**Seattle  
Design  
Commission**

**MINUTES OF THE MEETING**

**6 November 2003**

Projects Reviewed

### **Library, Community Center, and Park Design**

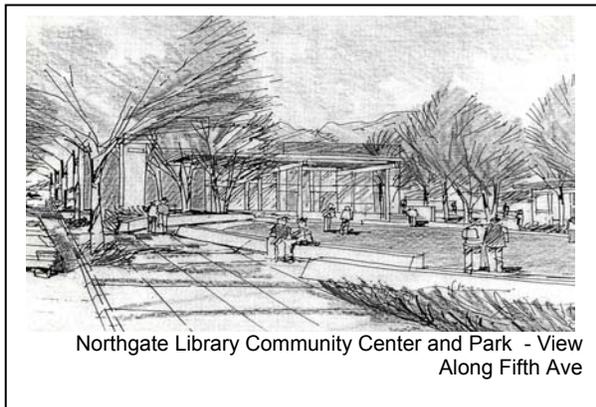
- Appreciates that the office of Policy Management attended this meeting.
- Would like to know how the library façade on 5<sup>th</sup> Ave activates the street edge even though the entrance is not on that side of the building.

- Proponents stated that the windows into the library will show a real working library rather than being static display windows.
- Questions what the visual cues are from 5<sup>th</sup> Ave that signal how to get to the library entrance.

- Notes that the pedestrian sequence entering from the south of the library is more successful than from the north.
  - Proponents noted that representatives from Seattle Public Libraries have made the same comment. Proponents stated that a window into the office on the North side of the building has been added in response to this concern.

- Feels that there is a disconnect between the street and the plaza.
- Suggests that the roof of the library should tilt away from the building in order to create a larger presence on the street.

- Suggests that the area immediately to the south of the library could be used as the urban plaza that connects to the sidewalk, instead of the current location midway along the length of the lawn. Notes that the area that is currently planned as a grove of trees could be made into an urban paved area.

- Notes that the play area seems separated from the main area of the park. Observes that children like to be part of the main activity. Also remarks that it is important to have the play area connected to the rest of the park for safety and visibility.

- Feels it would be helpful to have a site section that shows how the two buildings form the plaza space.
- Notes that the library seems very low. Wonders if the height has been dictated by budget concerns.

- Proponents stated that the library is not a particularly short building. They explained that the building is 16 feet tall to the underside of the wooden decking.

- Remarks that some other one story libraries are as much as 35 feet tall.
  - Proponents stated that the massing of the library is primarily a response to its adjacency to the park. They noted that this is a unique site opportunity that most libraries do not have.
